NSD-NRC-96-4814
DCP/NRC0598
Docket No.: STN-52-003

SUBJECT: AP600 LOFTRAN COMPUTER CODE ISSUE RESOLUTION

The attachment to this letter provides responses to NRC Supplemental Draft Safety Evaluation Report (SDSER) open items related to the LOFTRAN computer code and its application to AP600 safety analyses. The SDSER open items addressed in this letter are 21.6.1.4-1, 21.6.1.6-1, 21.6.1.7-1, 21.6.1.7-2, 21.6.1.7-3, 21.6.1.7-4, 21.6.1.7-5, 21.6.1.7-6, 21.6.1.7-7, 21.5.4-1, 21.5.4-2 and 21.5.4-3.

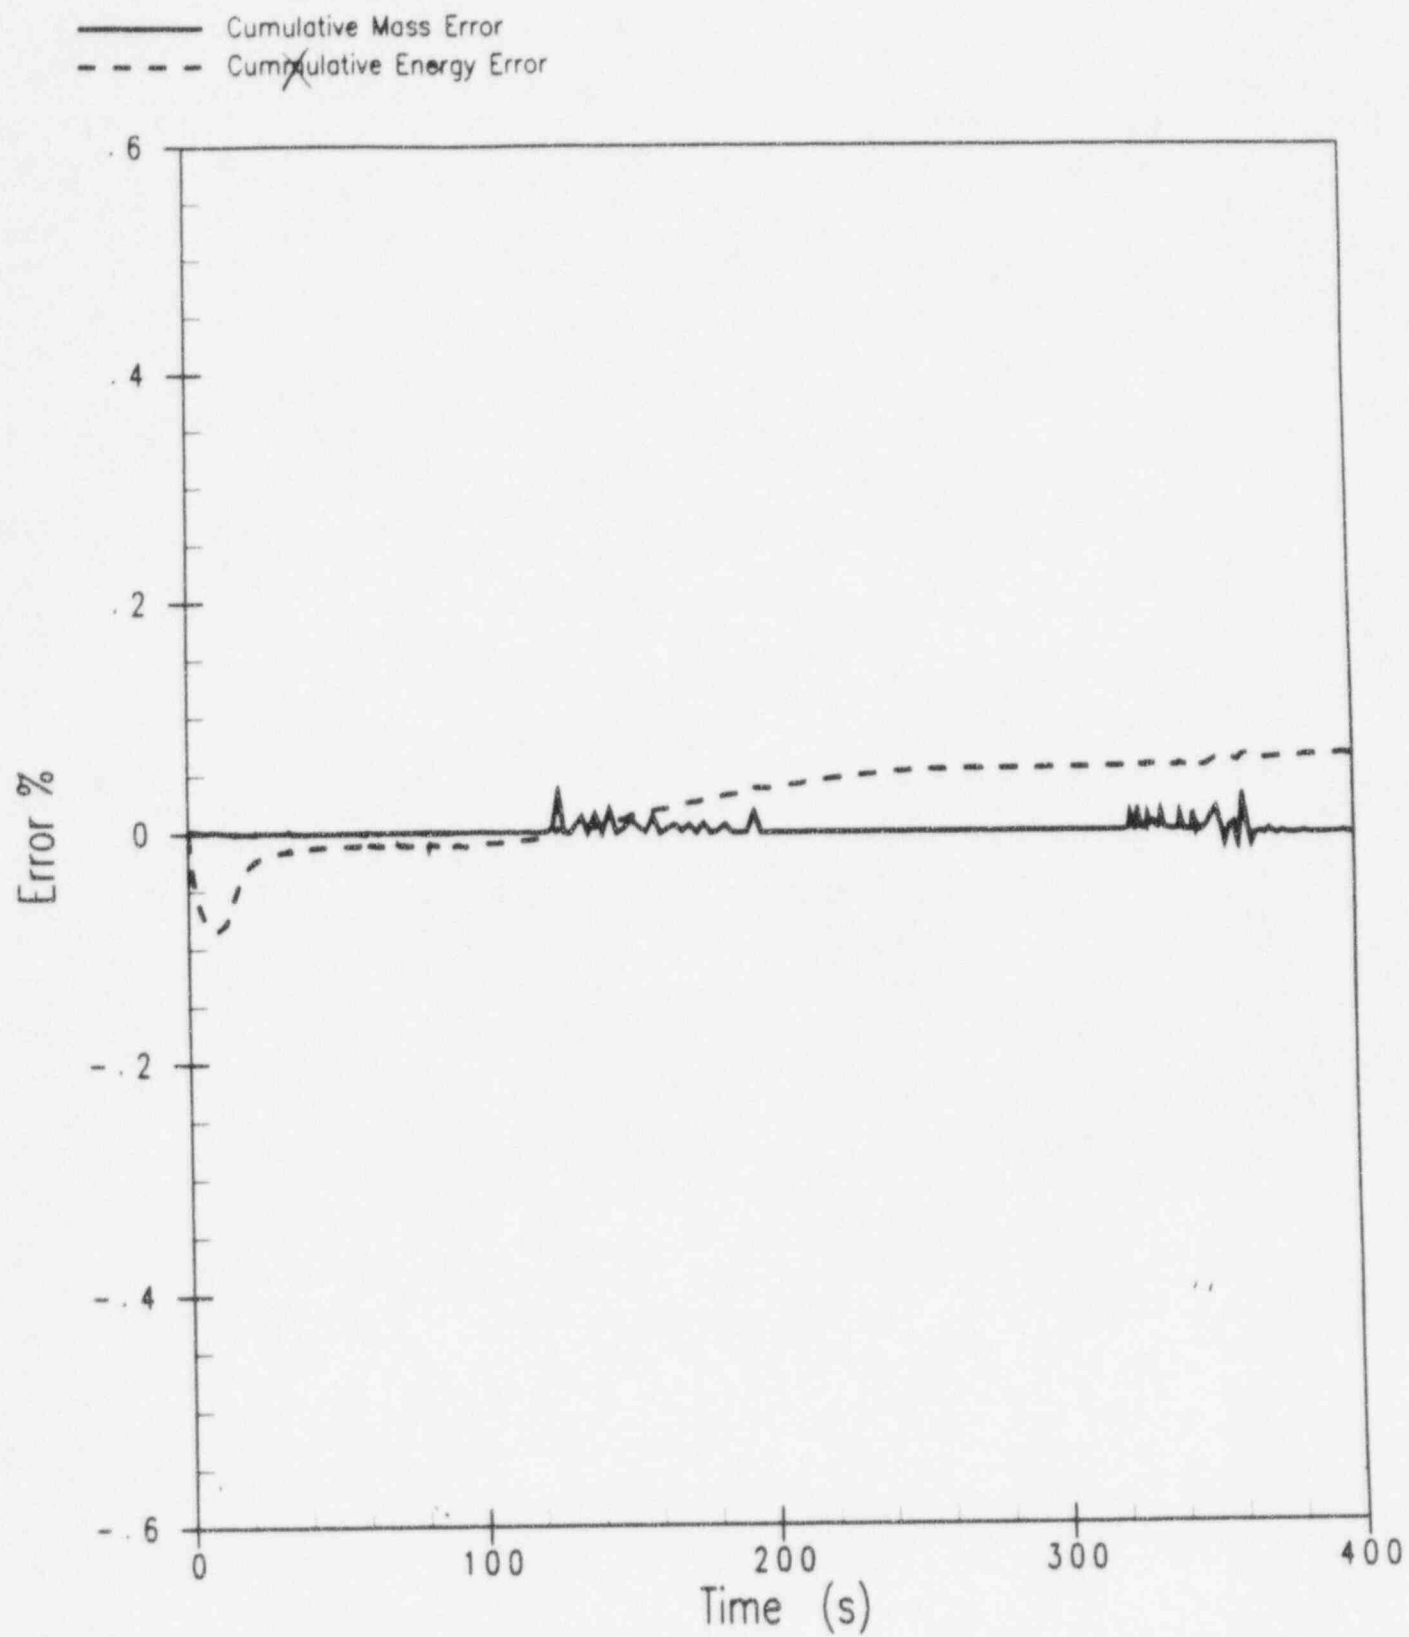
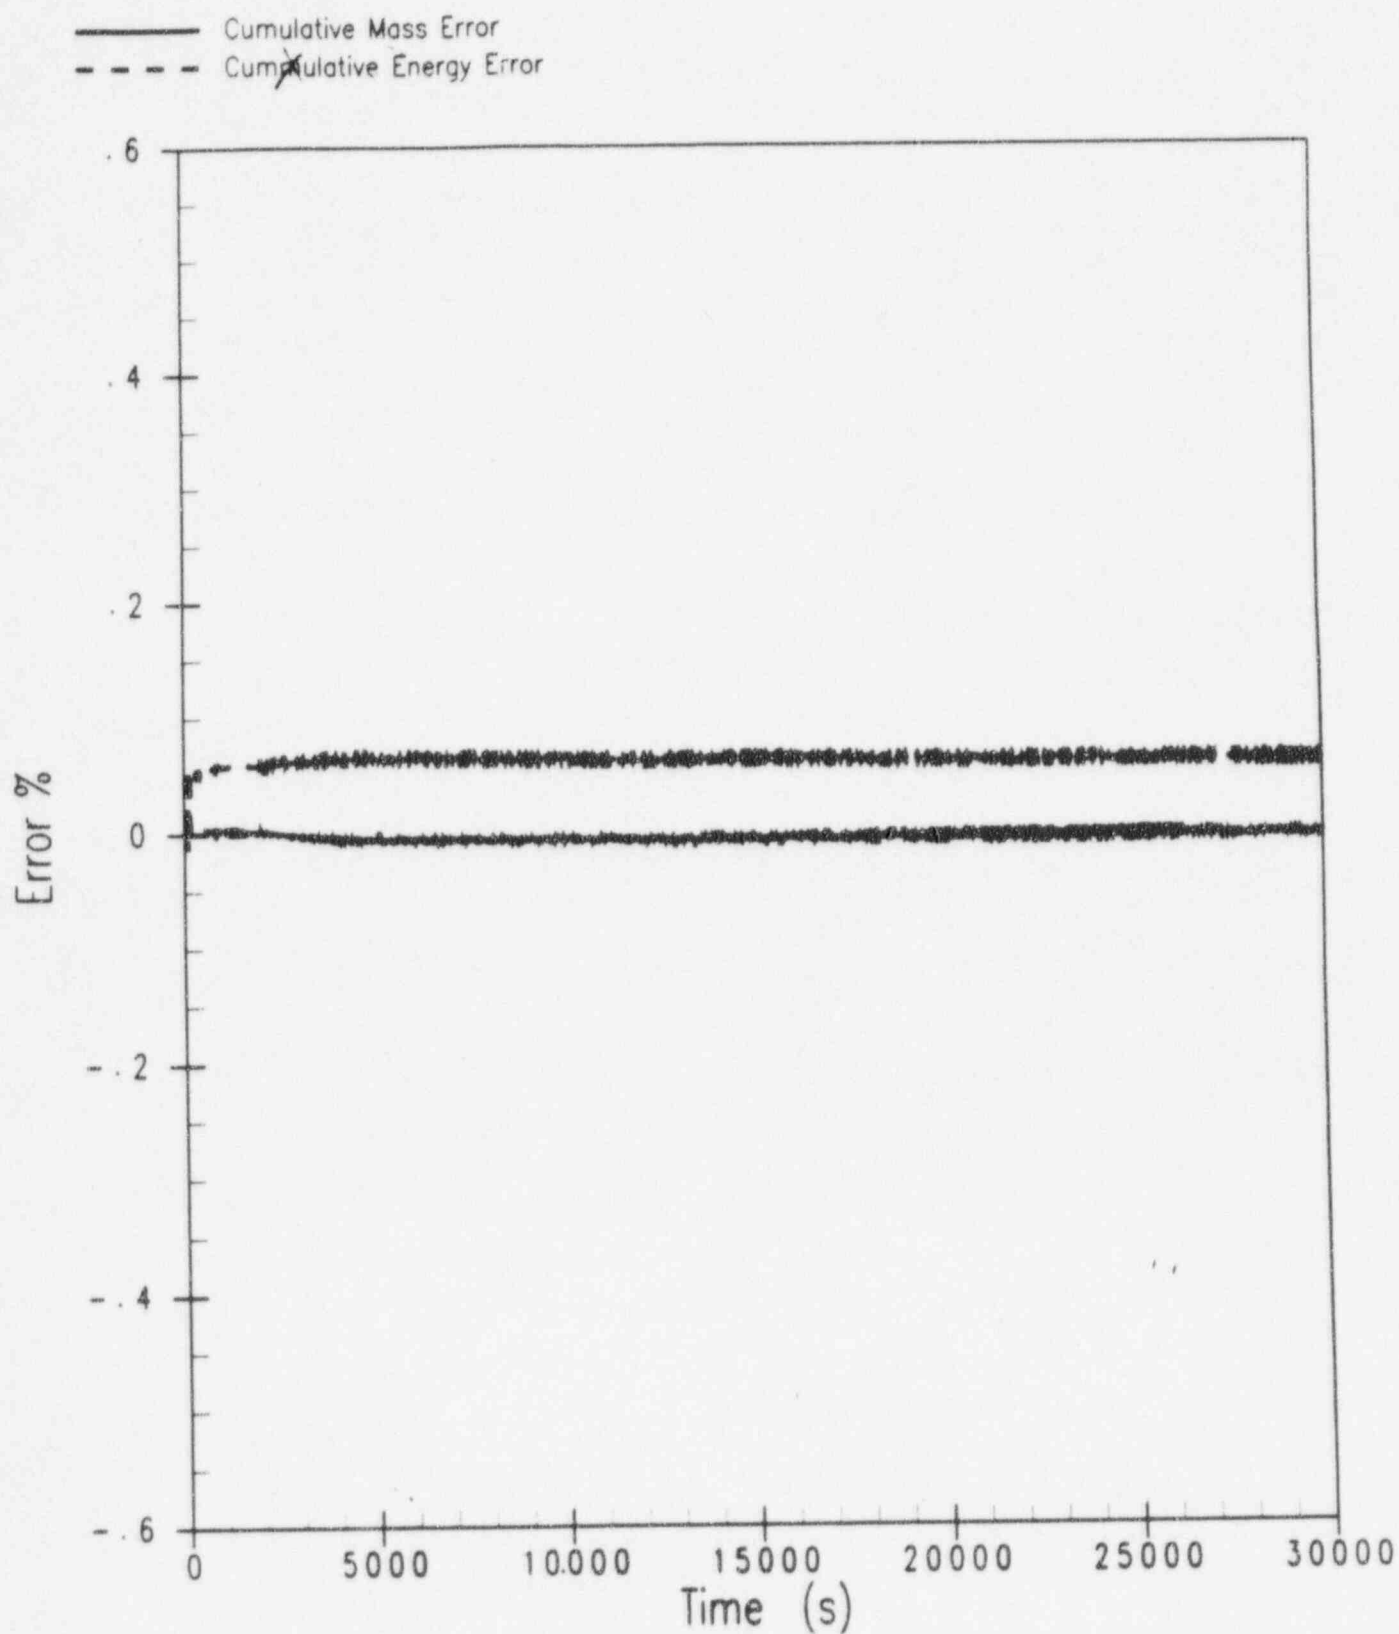
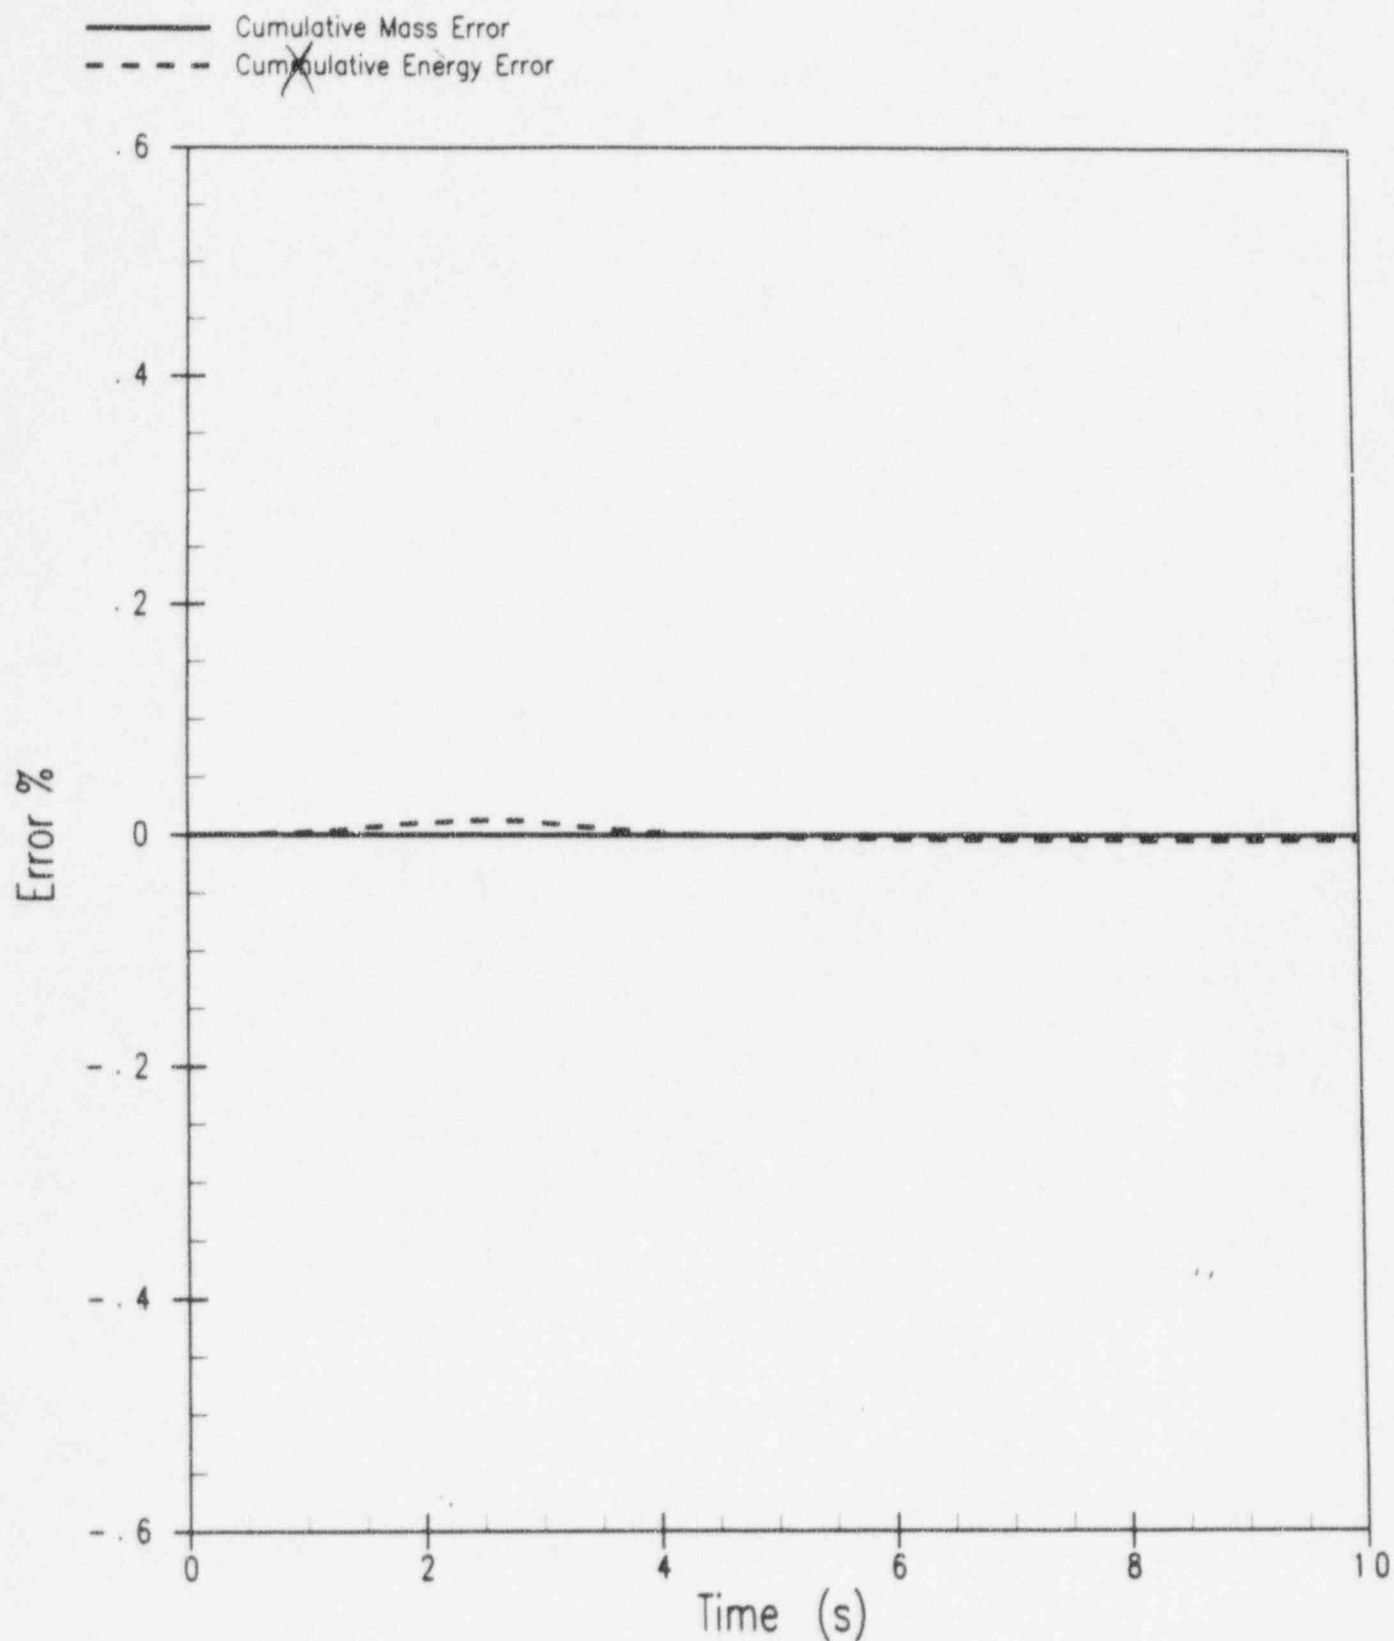
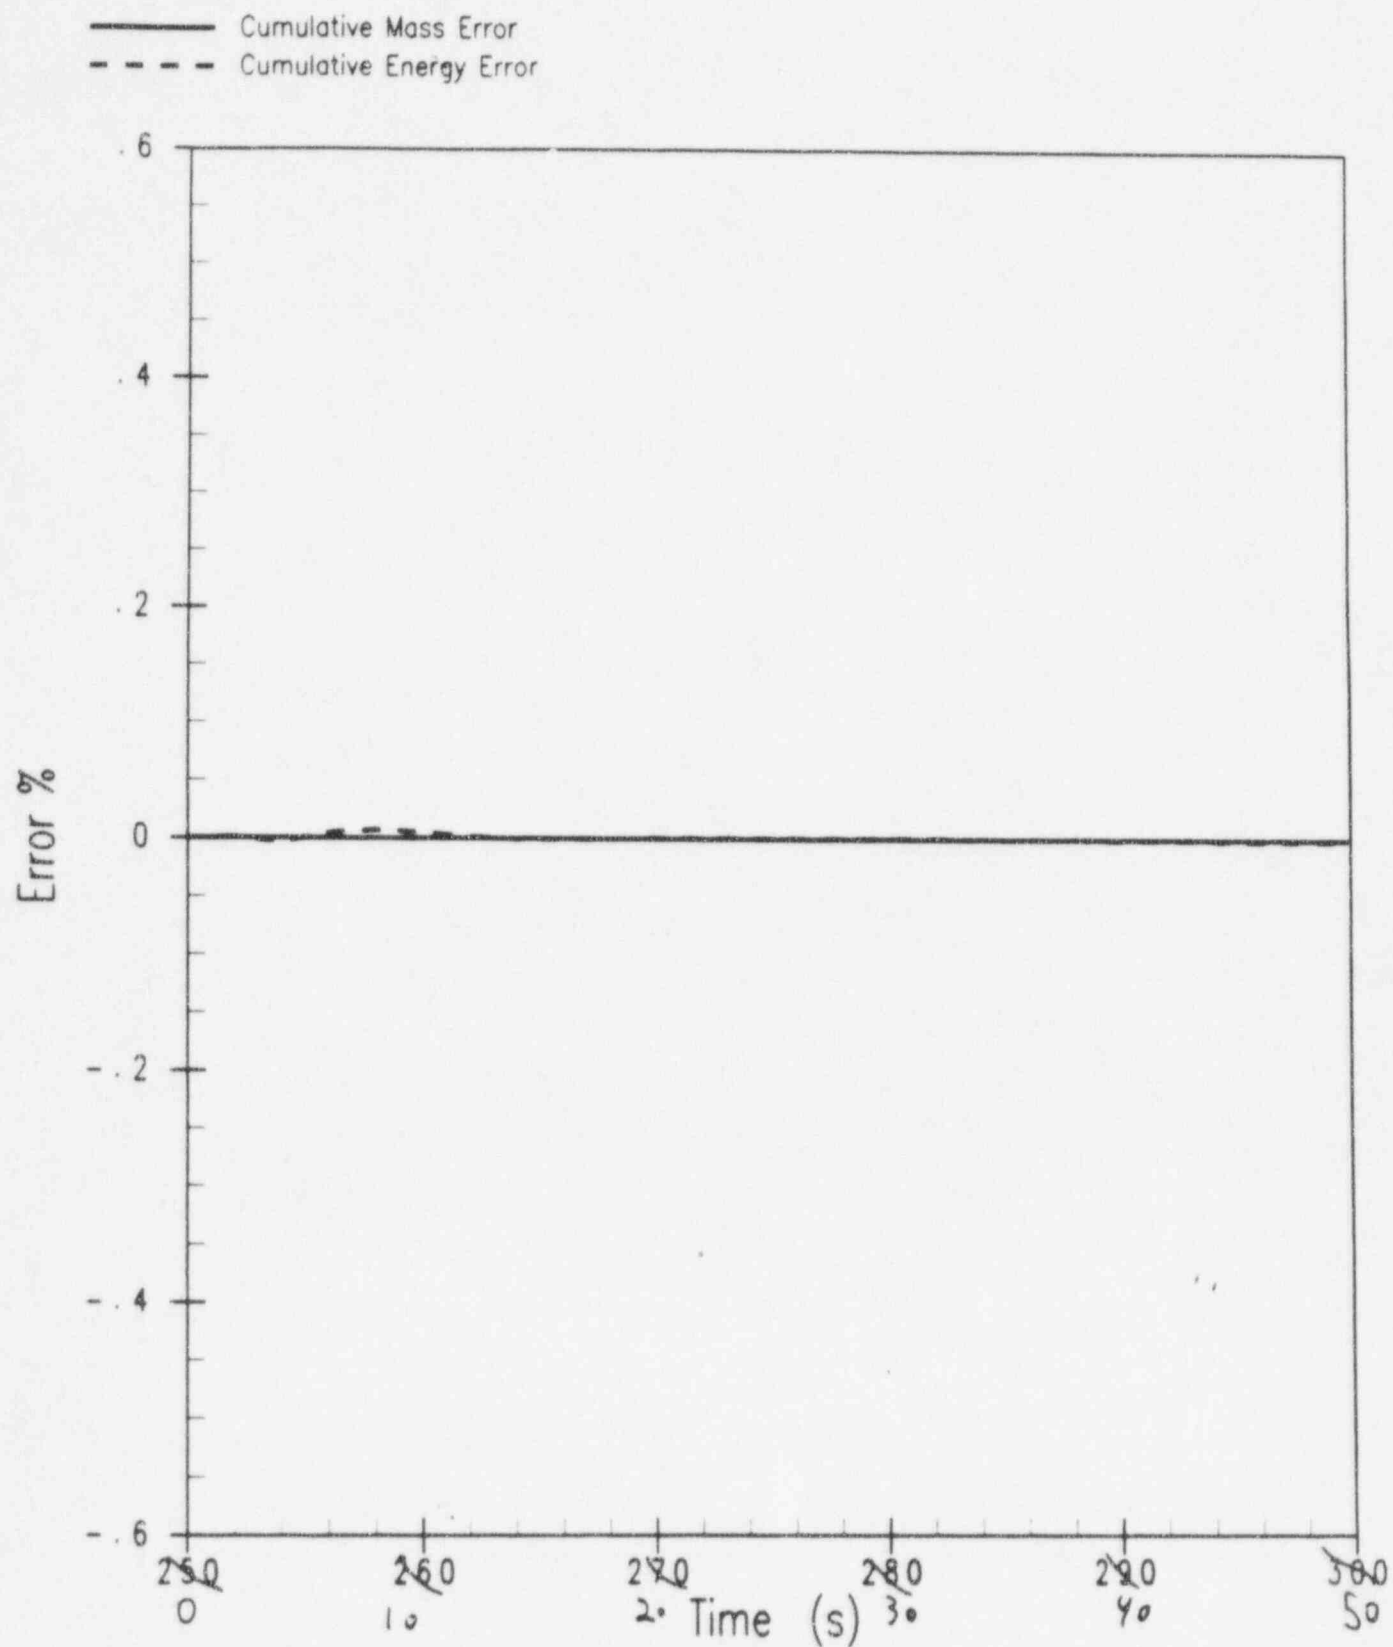
For each transient analyzed with LOFTRAN, Westinghouse needs to submit information on the impact of not conserving mass, energy, momentum, and volume.

Mass and energy balances were performed (using the methodology described in the response to RAI 440.288) to verify that the LOFTRAN/LOFTTTR2 codes used for the AP600 non-LOCA and SGTR analyses conserve mass and energy with a reasonable degree of accuracy. Mass and energy balances were performed for a transient from each of the six main design basis accident sections of the SSAR where LOFTRAN is used. The results of these calculations are presented in Table 1, which shows that there is no appreciable mass or energy error developed for any of the LOFTRAN transients. Figures 1-6 present the transient mass and energy balances for the selected transients.
